Working Draft American National Standard

Project T10/1760-D

Information technology - Serial Attached SCSI - 2 (SAS-2)

Summary of Comments on Serial Attached SCSI - 2 (SAS-2) Standard

Figure 10 — SAS Domain class diagram

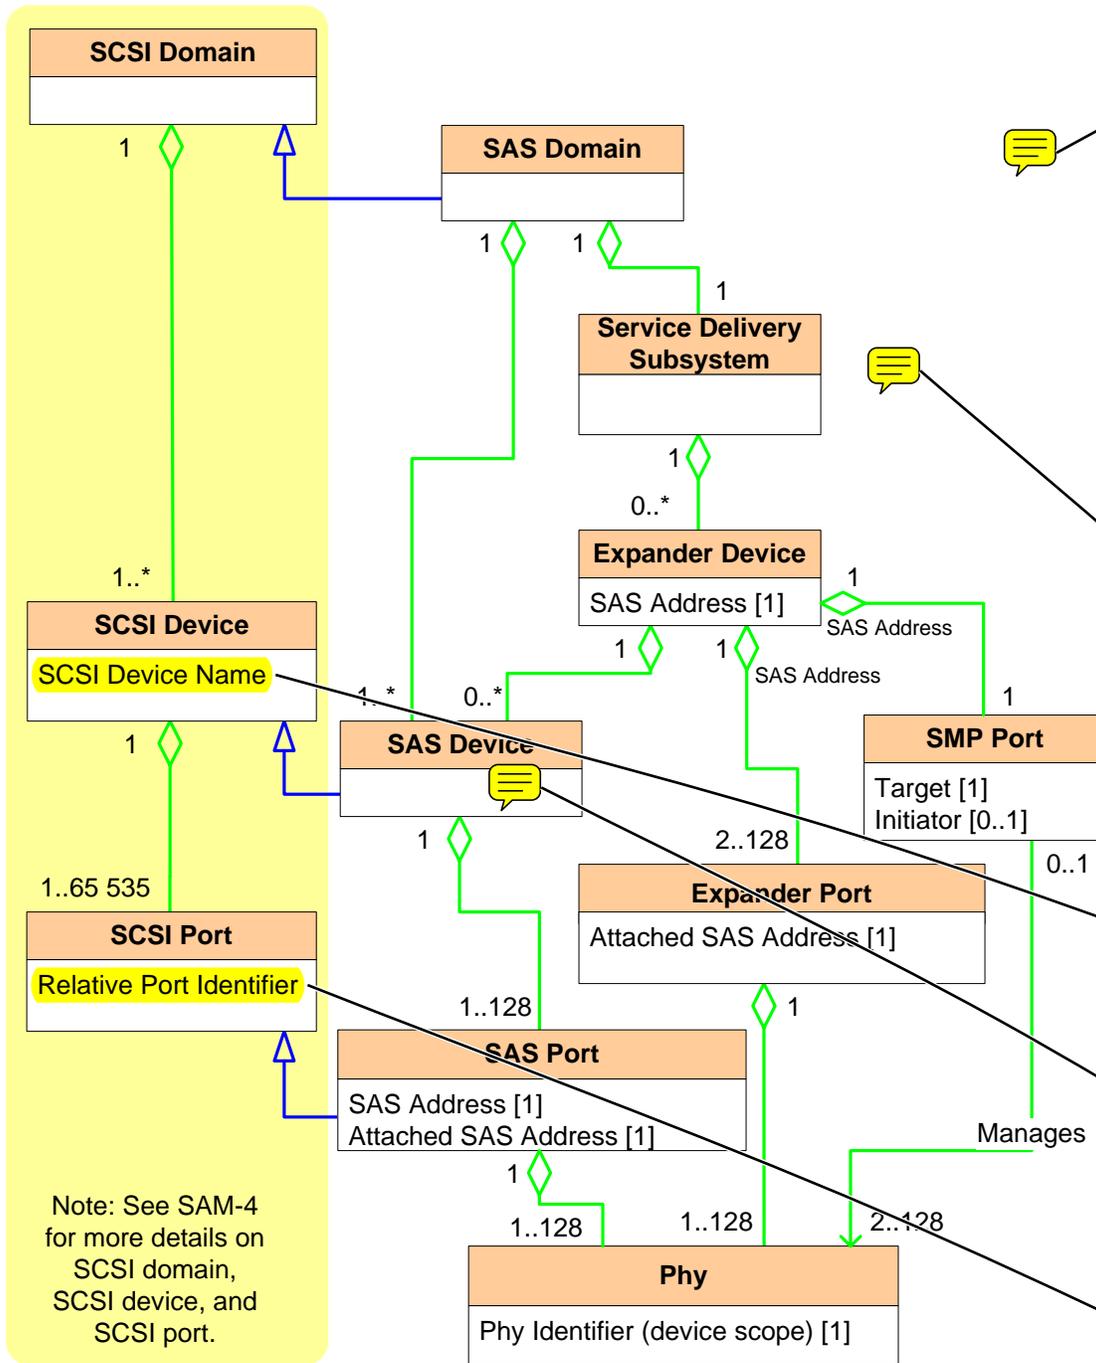
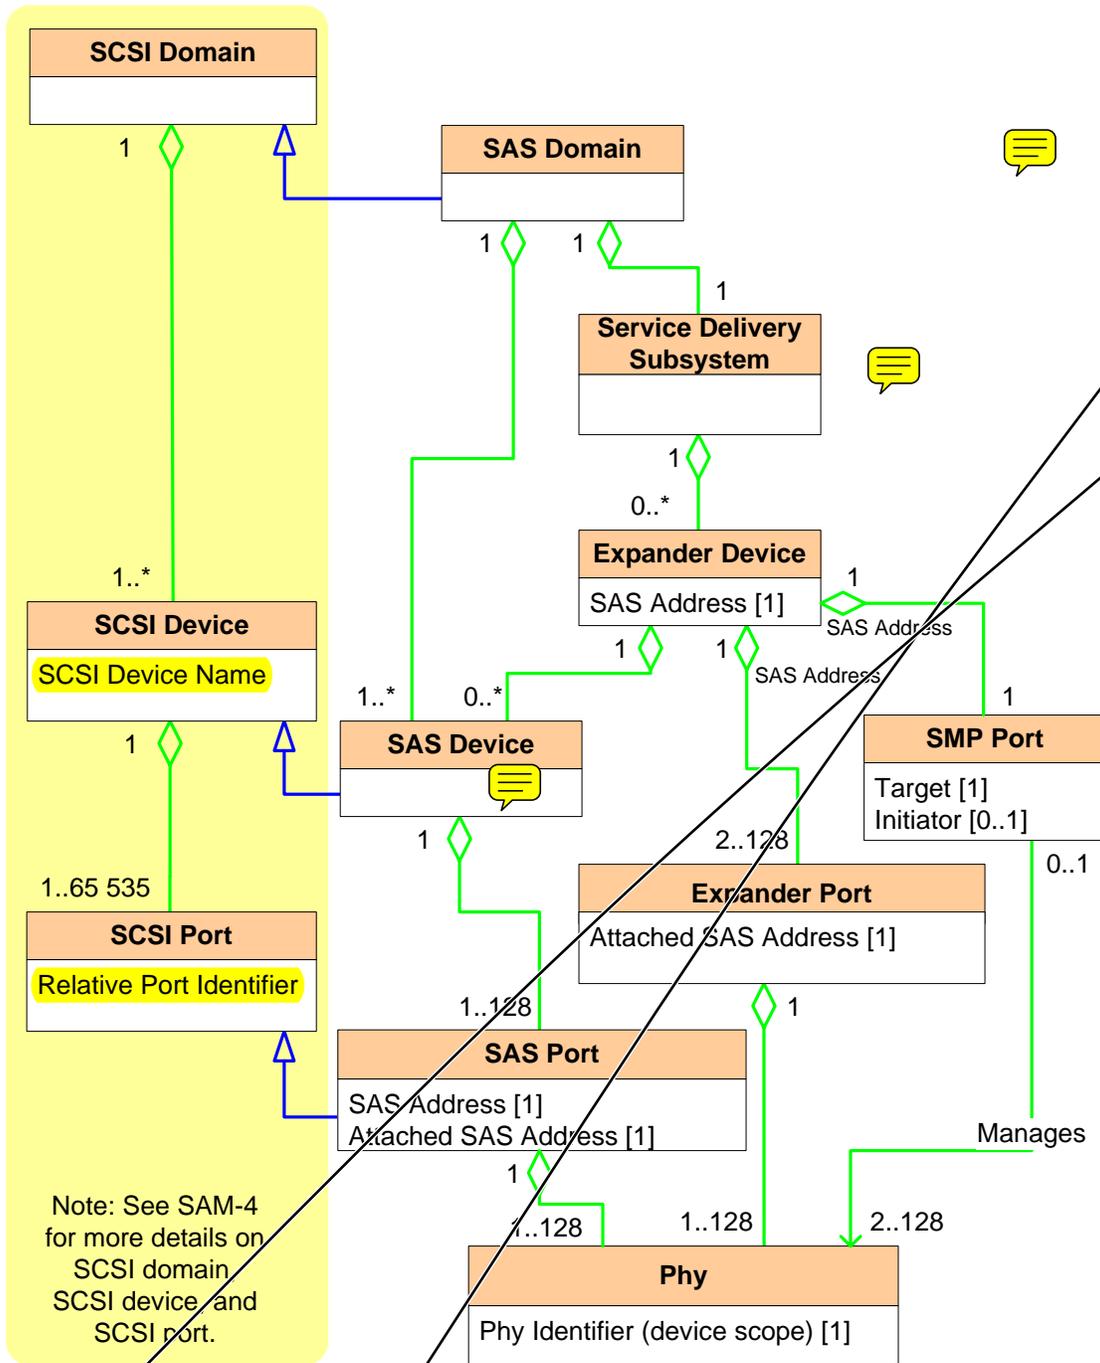
figure 10: changed 1..128 to 1..255

figure 10: changed 2.. to 2..255

Figure 16 — Port class diagram

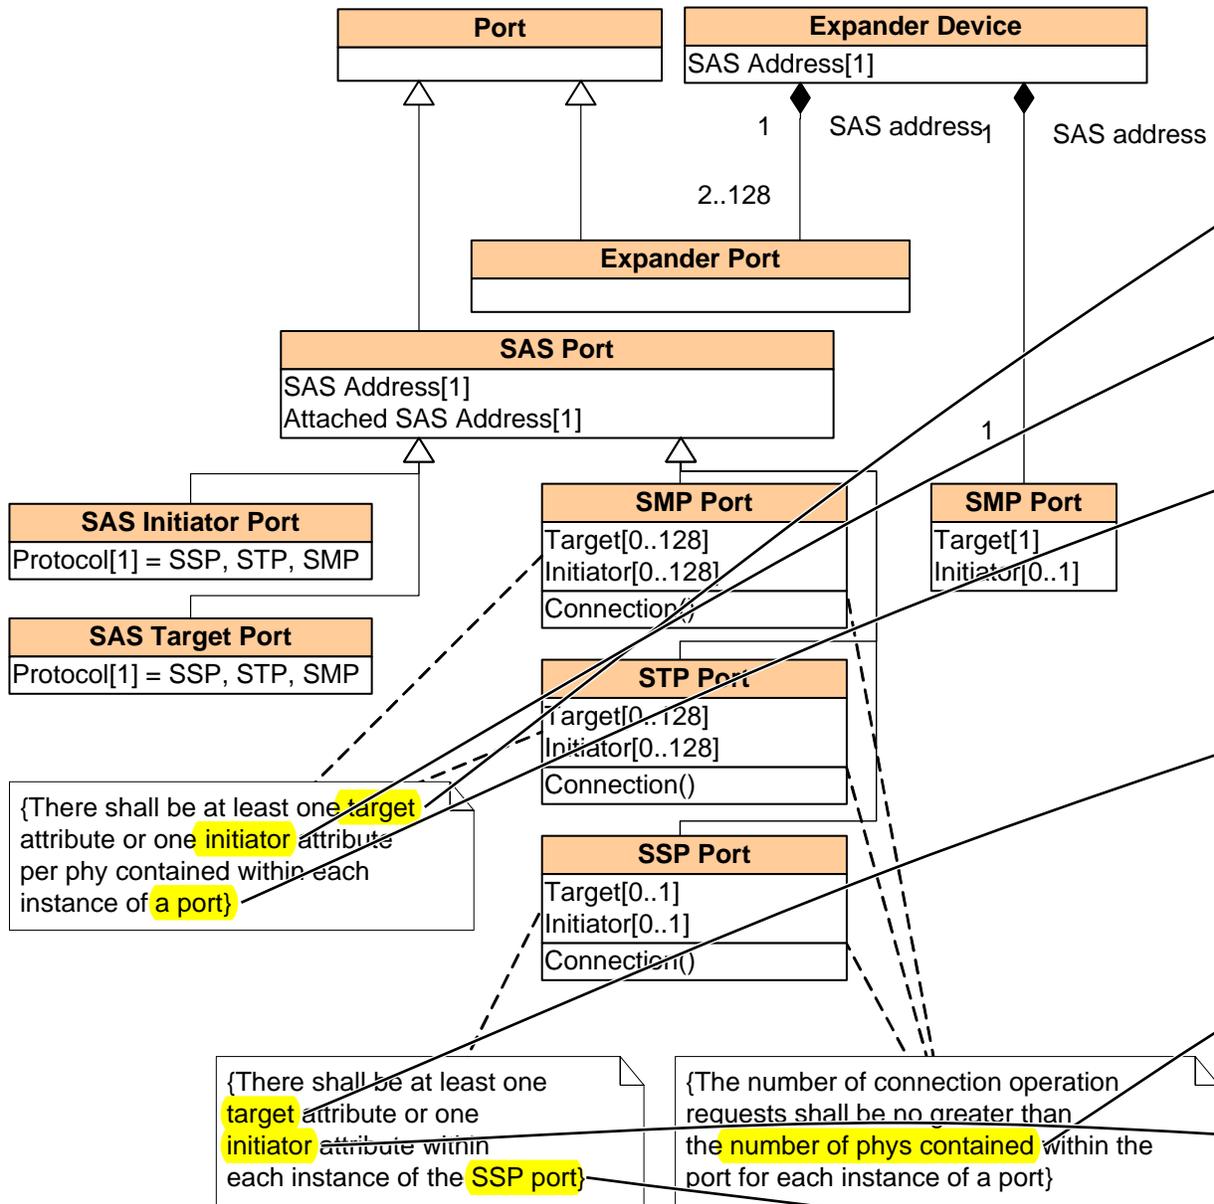
figure 16: changed [0..128] to [0..255] (zero to 255 possible phys)

figure 16: changed 2..128 to 2..255

Should be << detail is not shown. However, each port

Figure 31 — Transmit data path in a SAS phy

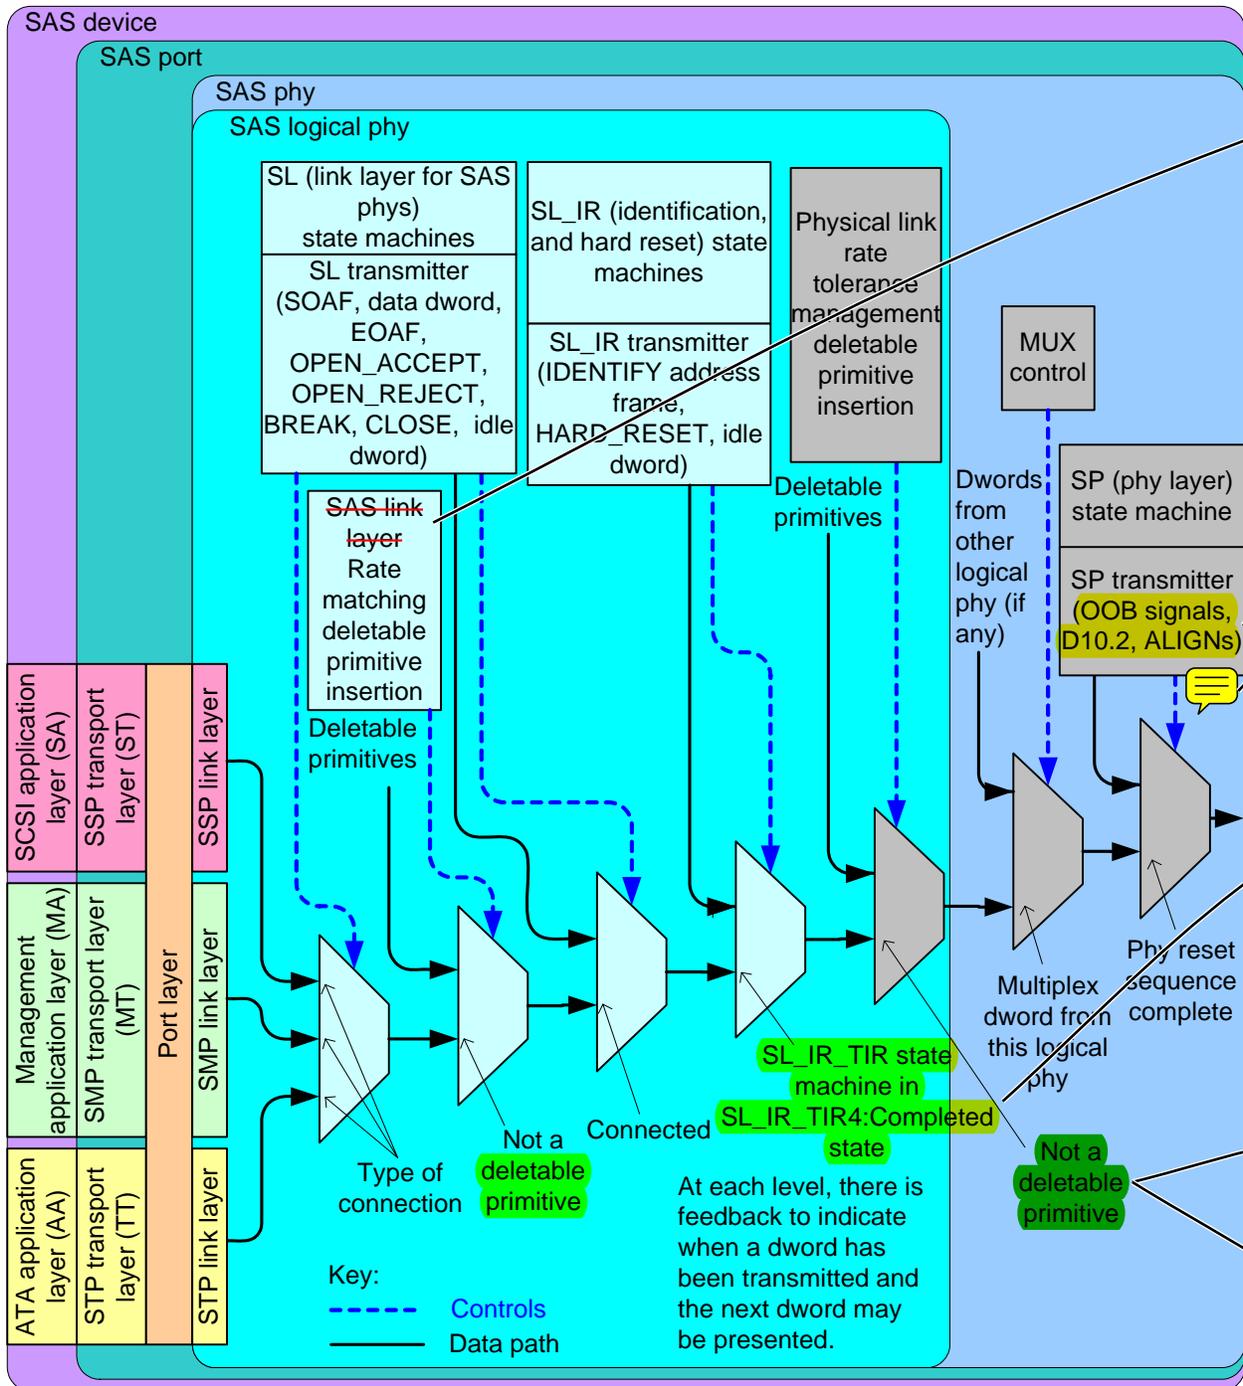
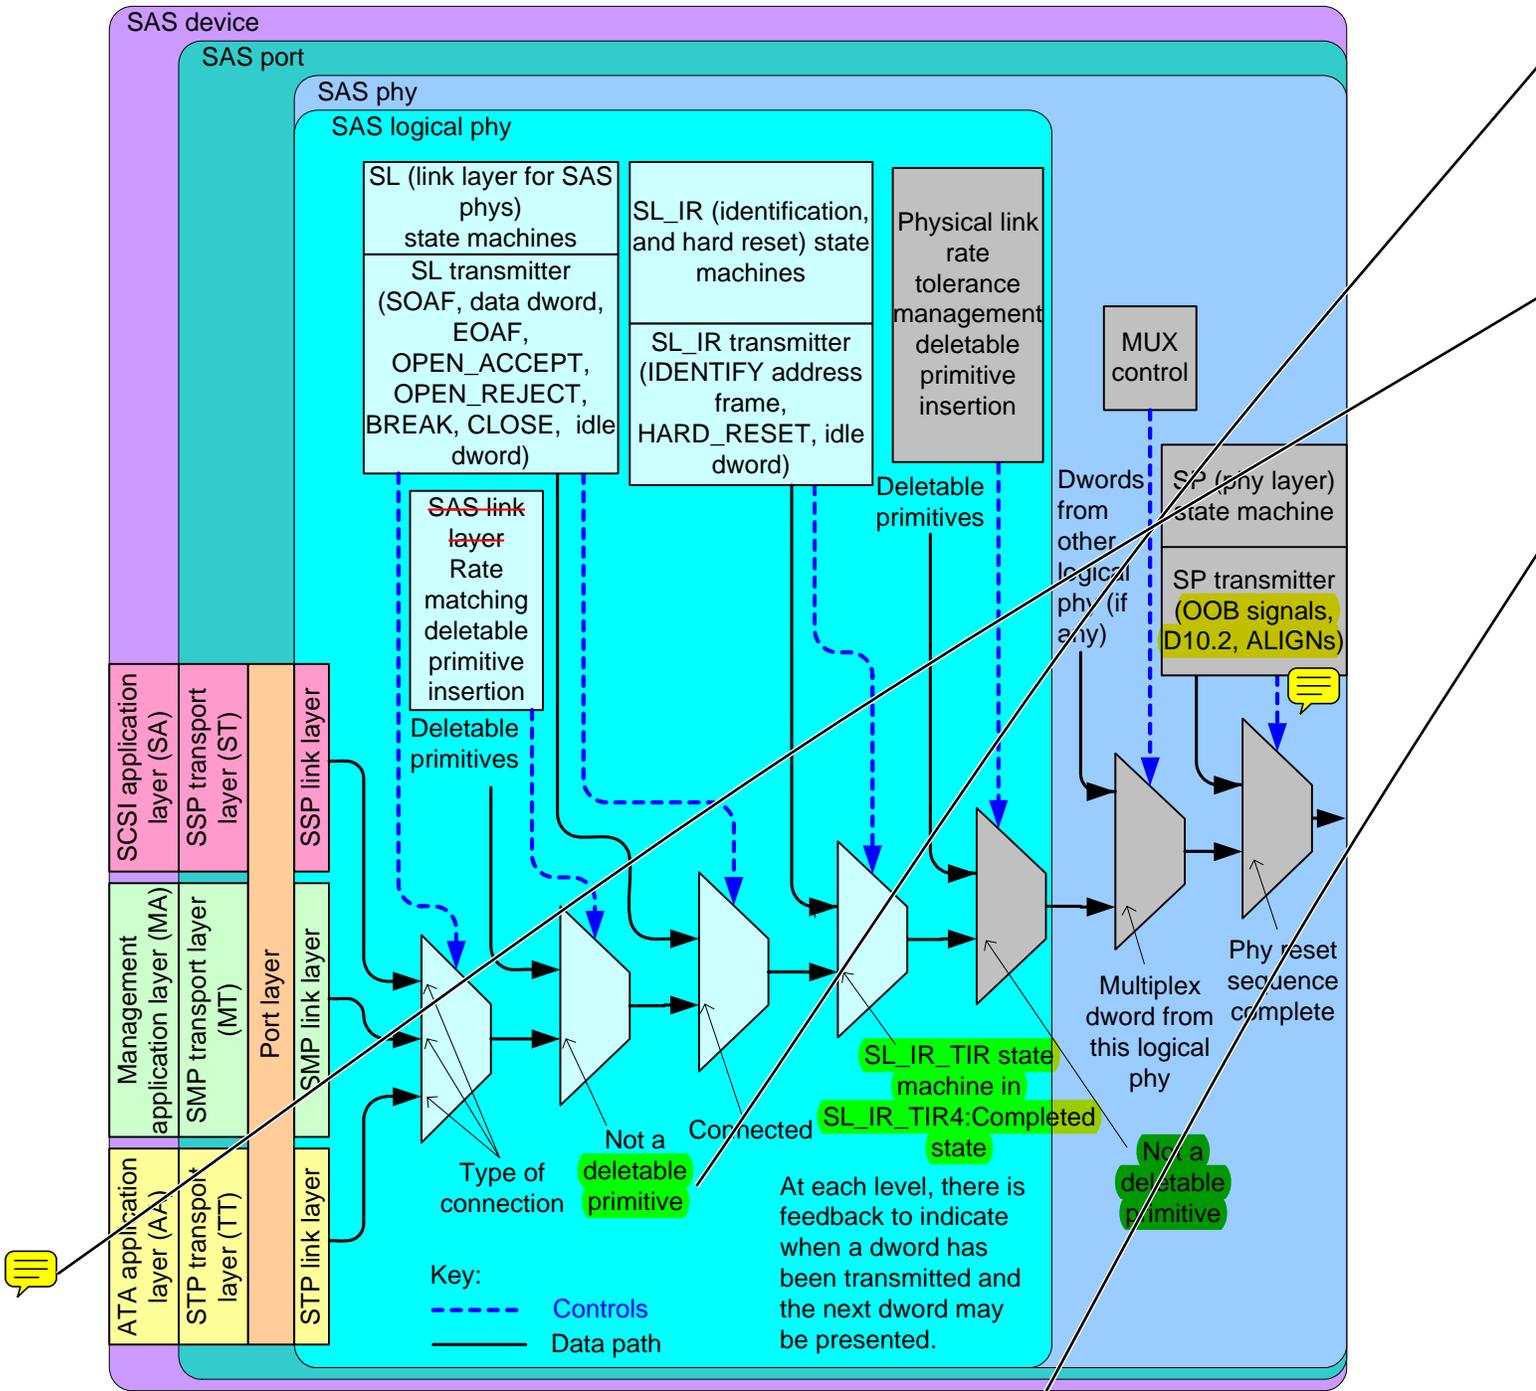
NOTE
s/b
Note

Figure 38 — State machines and SAS Device classes

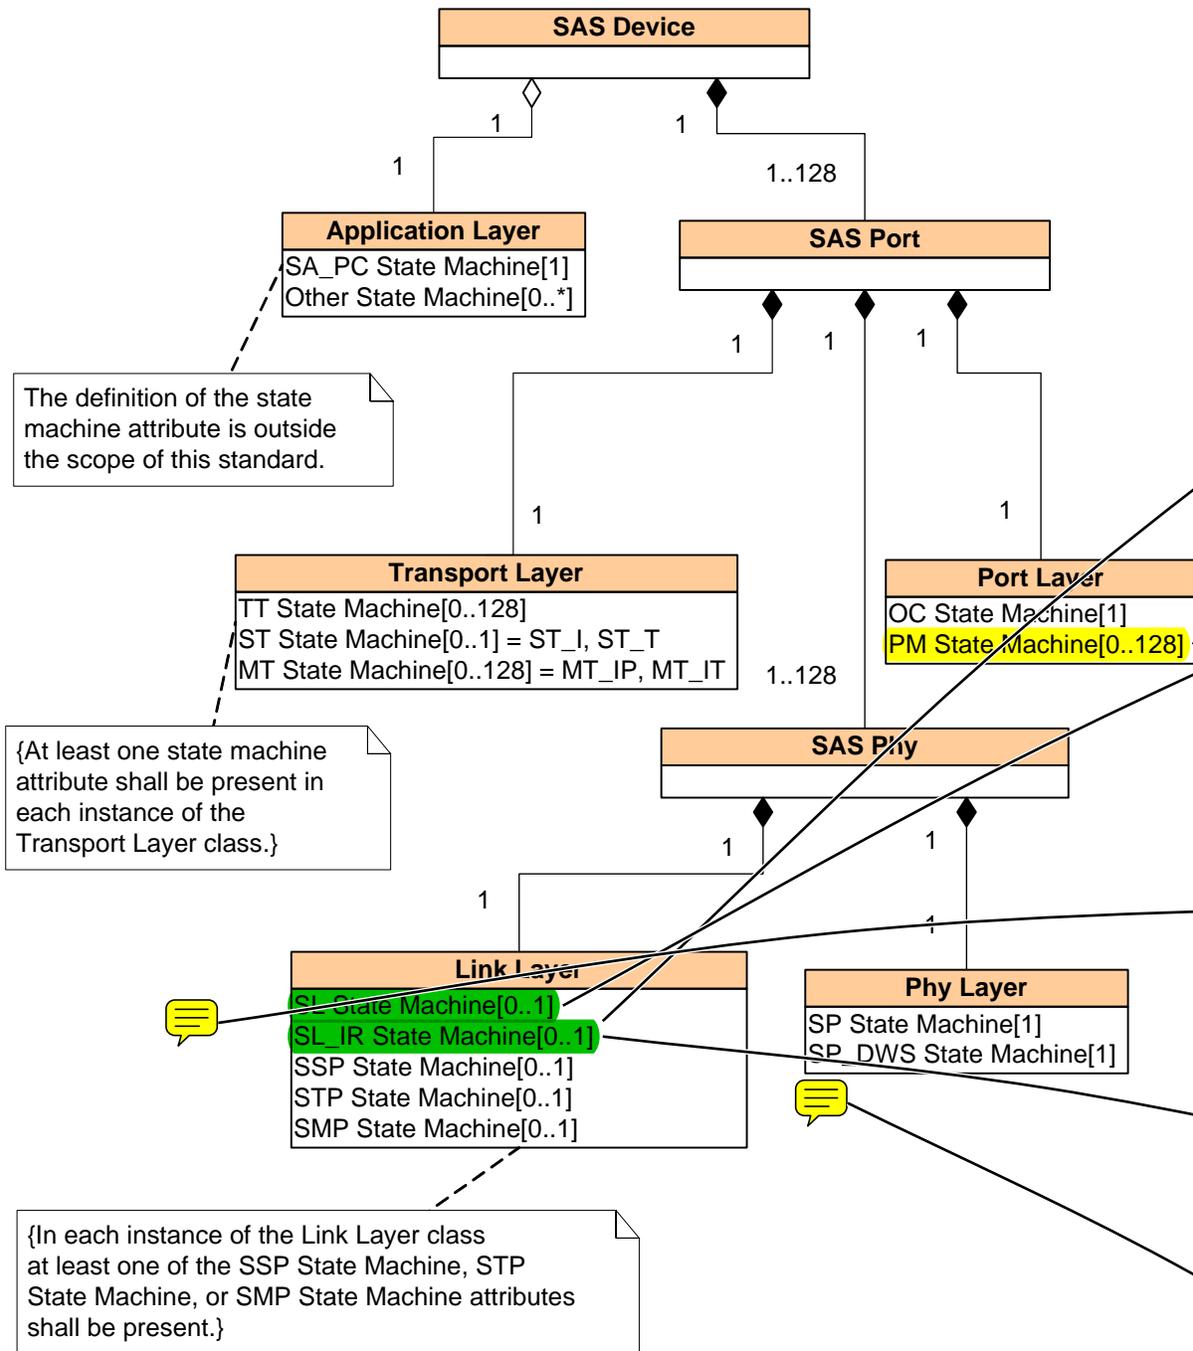
also figure 38: 0..128 to 0..255

also figure 38: 1..128 to 1..255
